BURY COUNCIL
DEPARTMENT FOR RESOURCES AND REGULATION
PLANNING SERVICES

PLANNING CONTROL COMMITTEE

21 January 2020

SUPPLEMENTARY INFORMATION

drawing No rev
P213-100/A

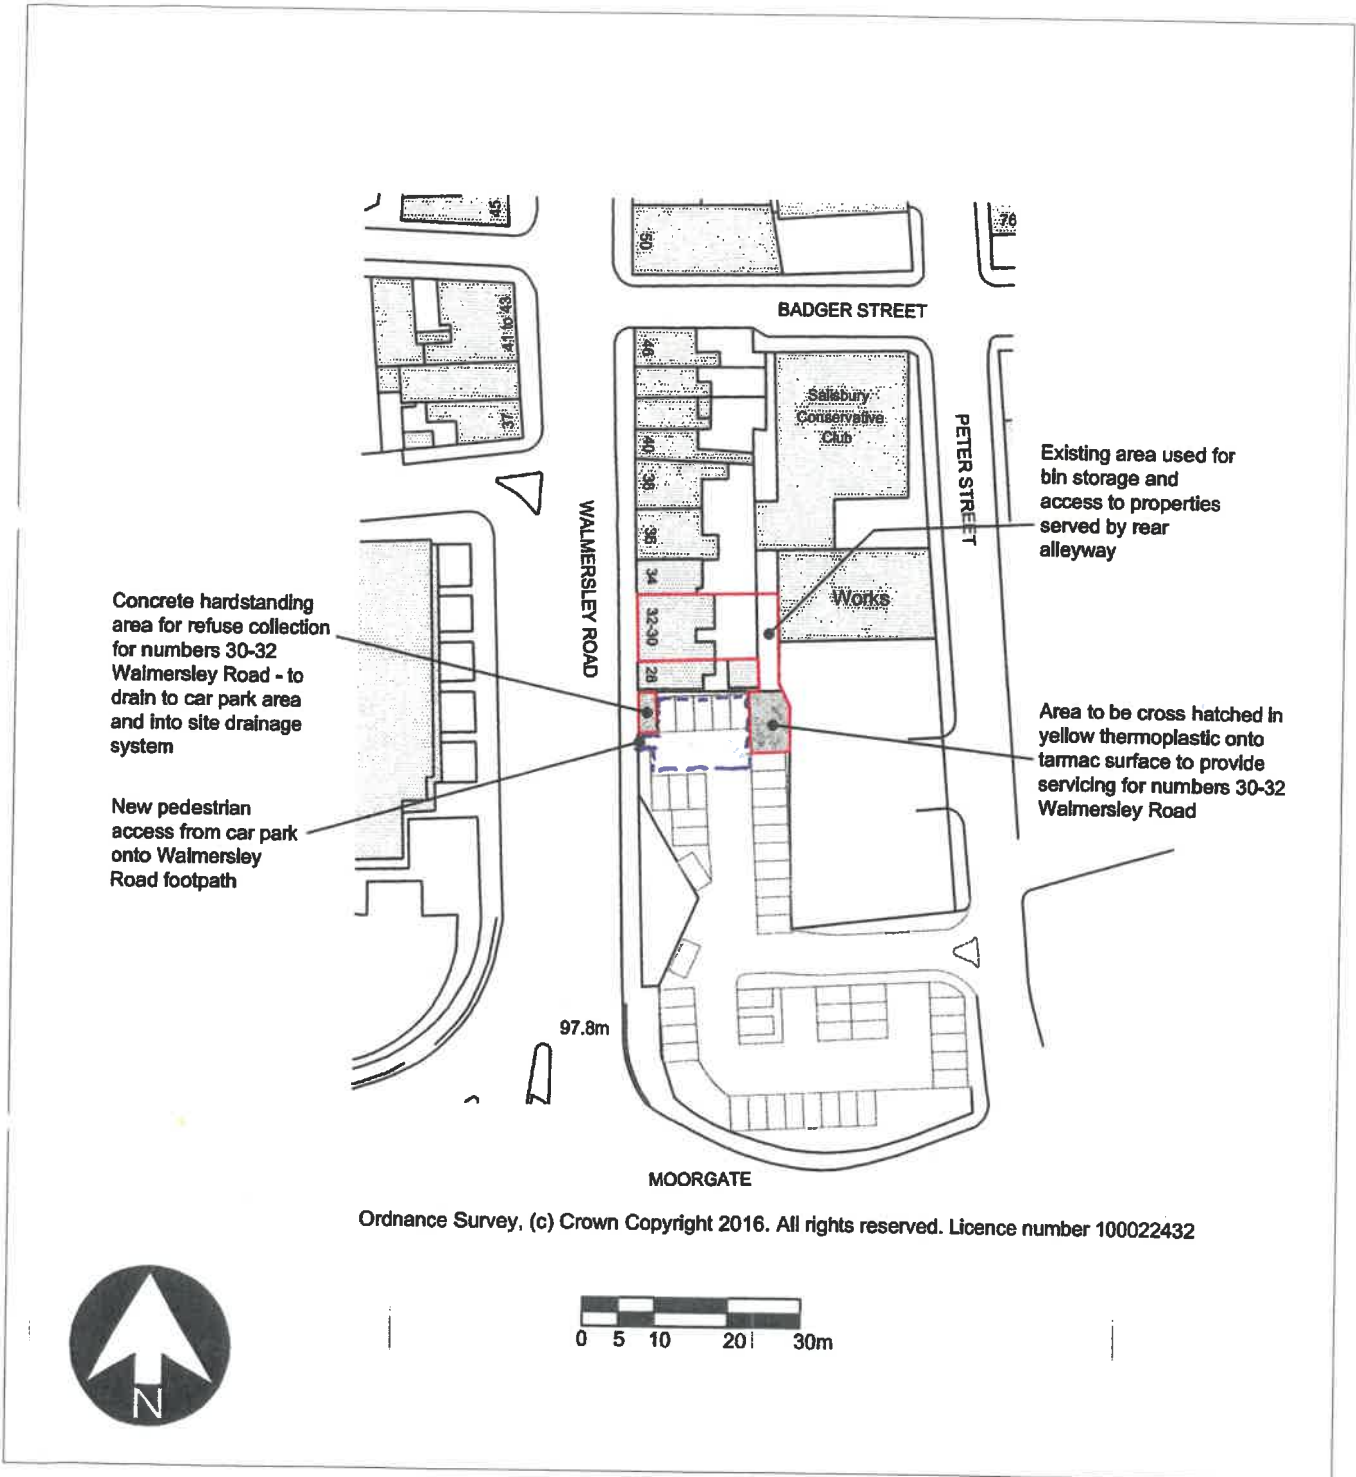
The revised location plan (P213-100/A) includes land outlined in blue (dotted), indicating ownership by the applicant. This indicates access can be gained from the rear bin storage and service area to Walmersley Road.
